CITY OF OKEECHOBEE

Application for Site Plan Review

Proposed Civil Plans FOR Williamson Cattle Company Brahman Carwash

Staff Report Site Plan Review:

PAVING, GRADING AND DRAINAGE PLAN

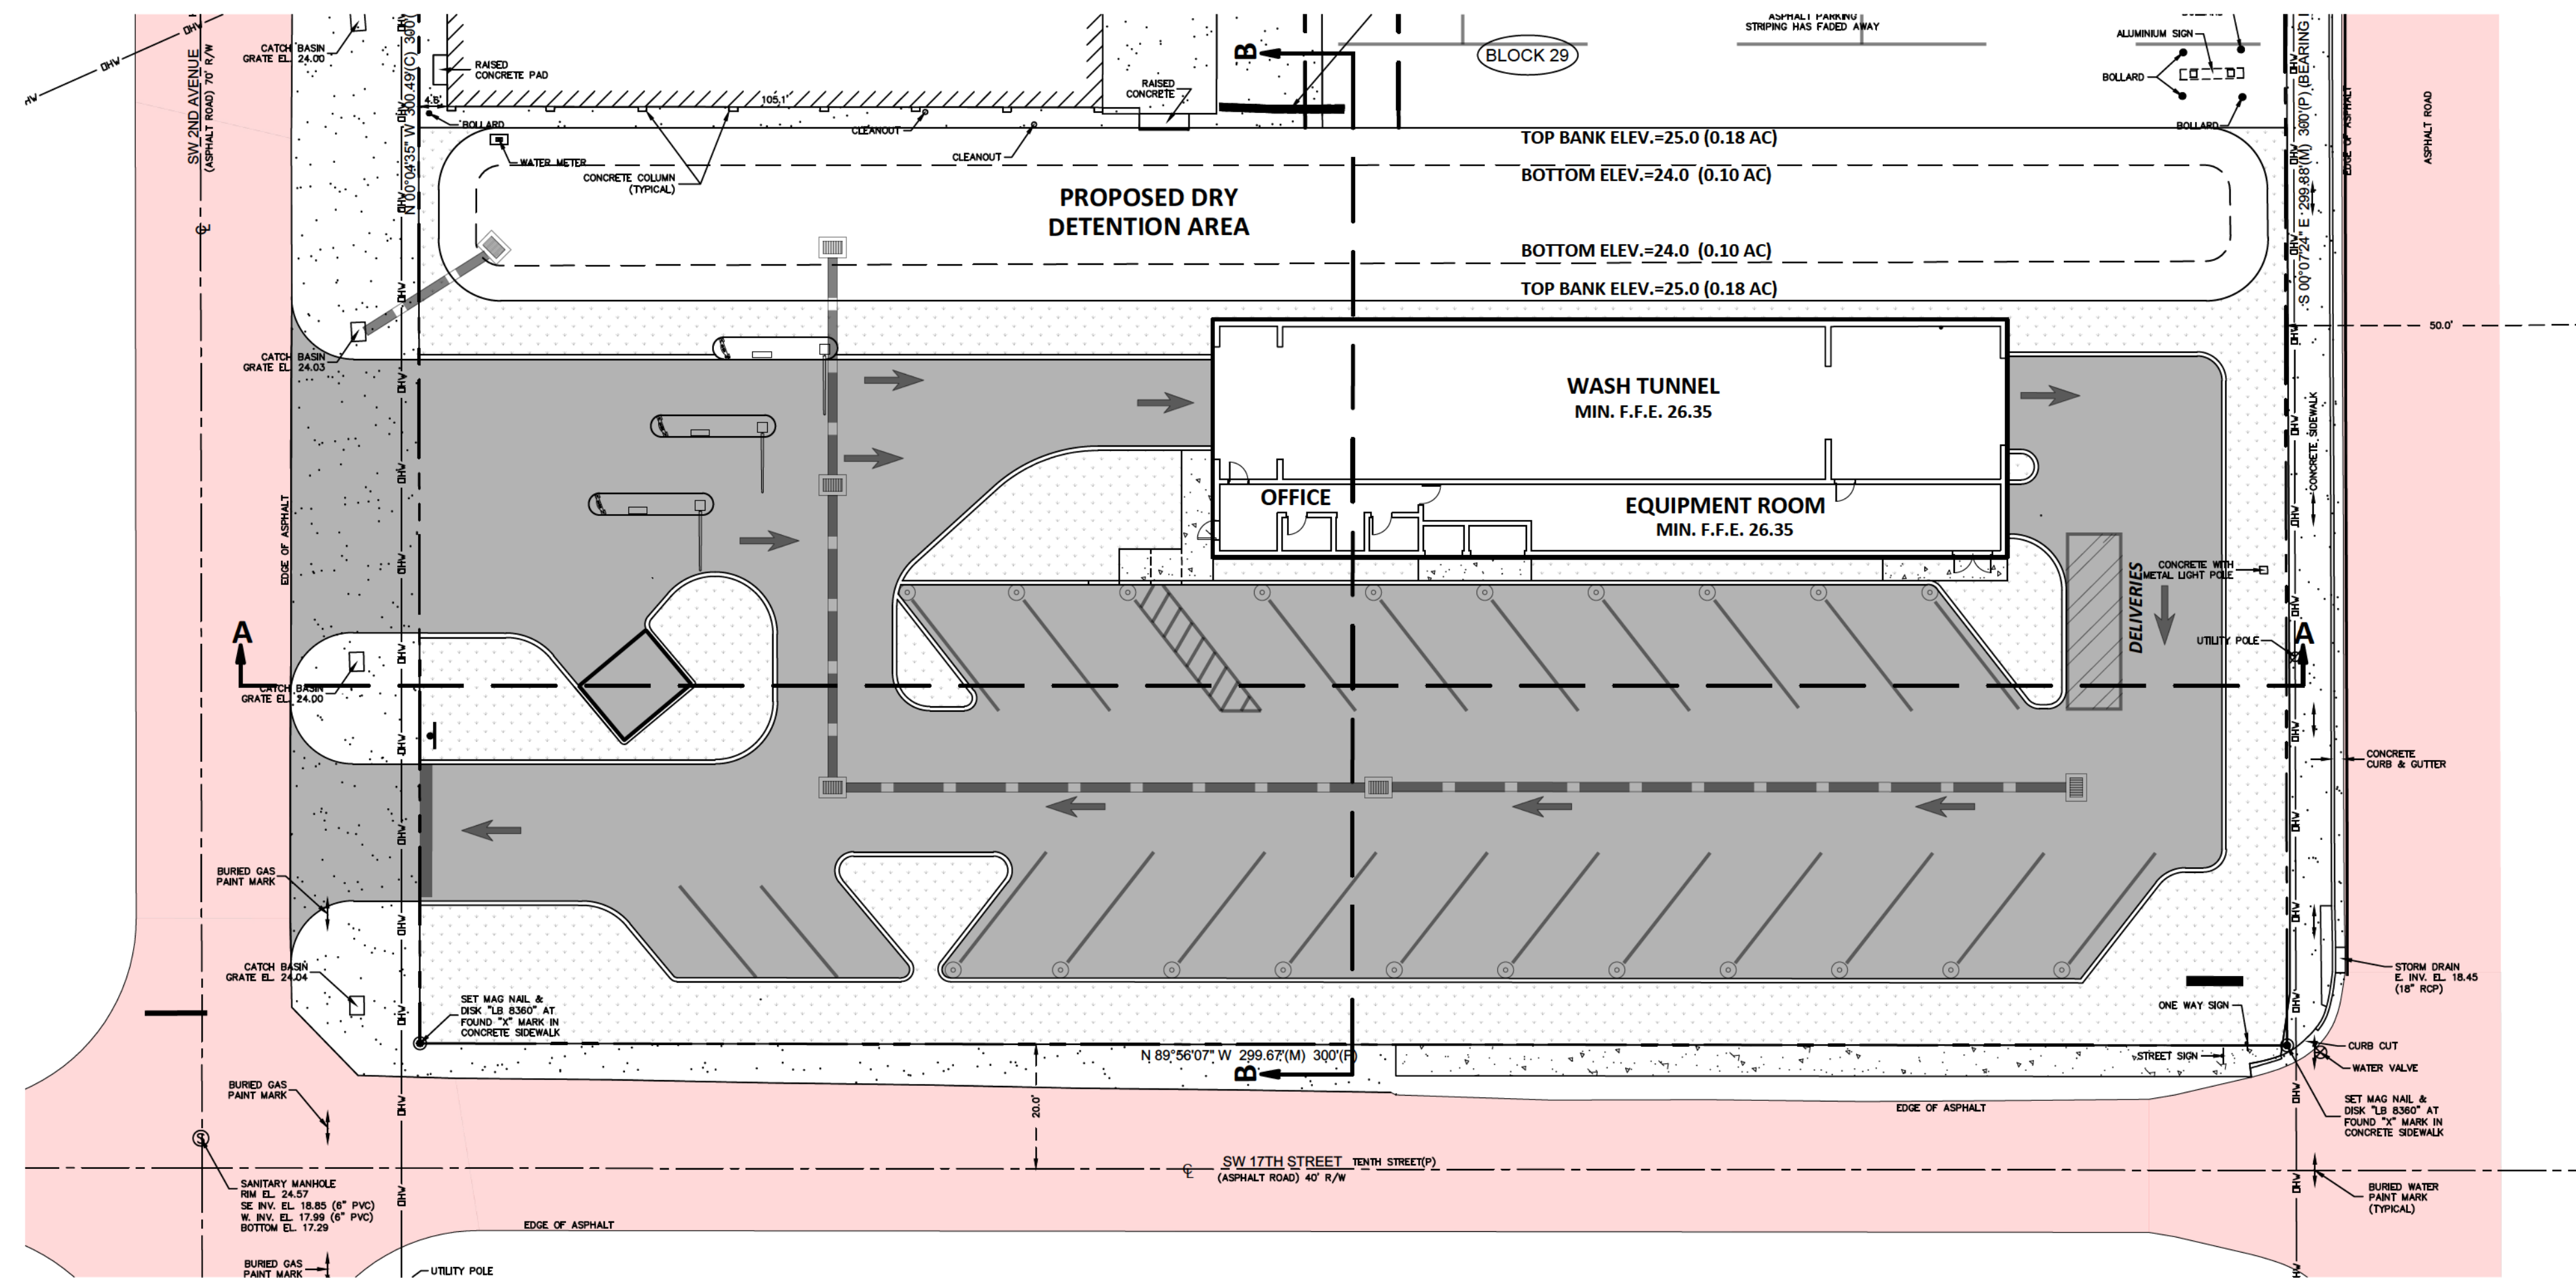
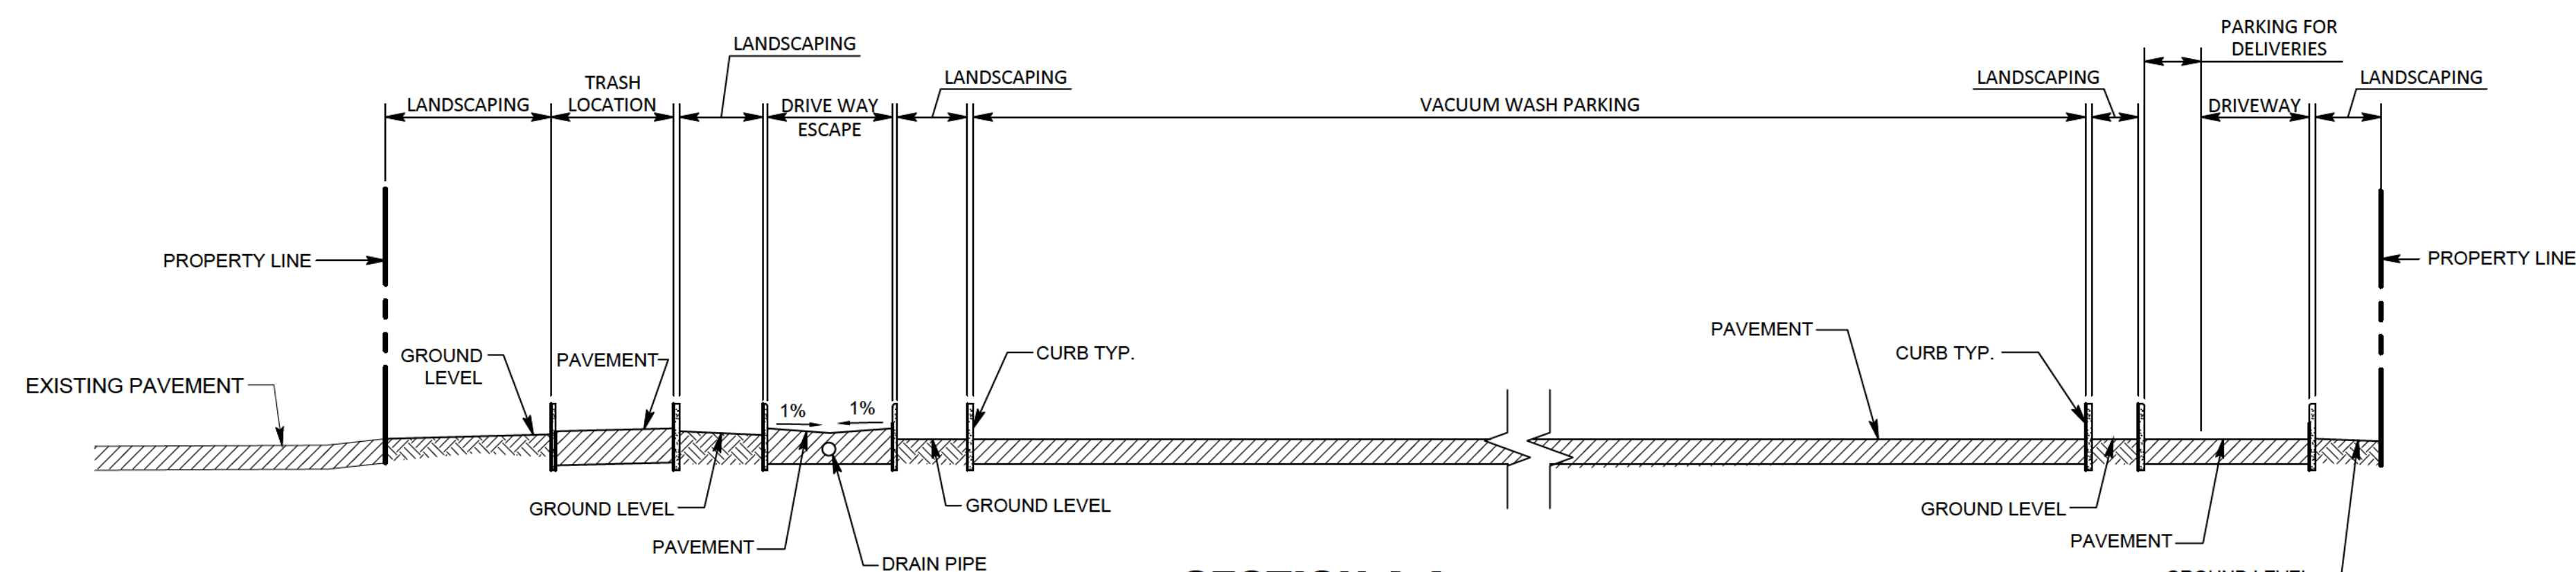
The Applicant has provided a drainage report and the site plan includes a stormwater retention feature, both of which will require review by the City’s engineering service.

6. The City's engineering service should review the proposed stormwater facilities and the submitted drainage report to ensure on site stormwater will be captured and released according to all applicable standards.
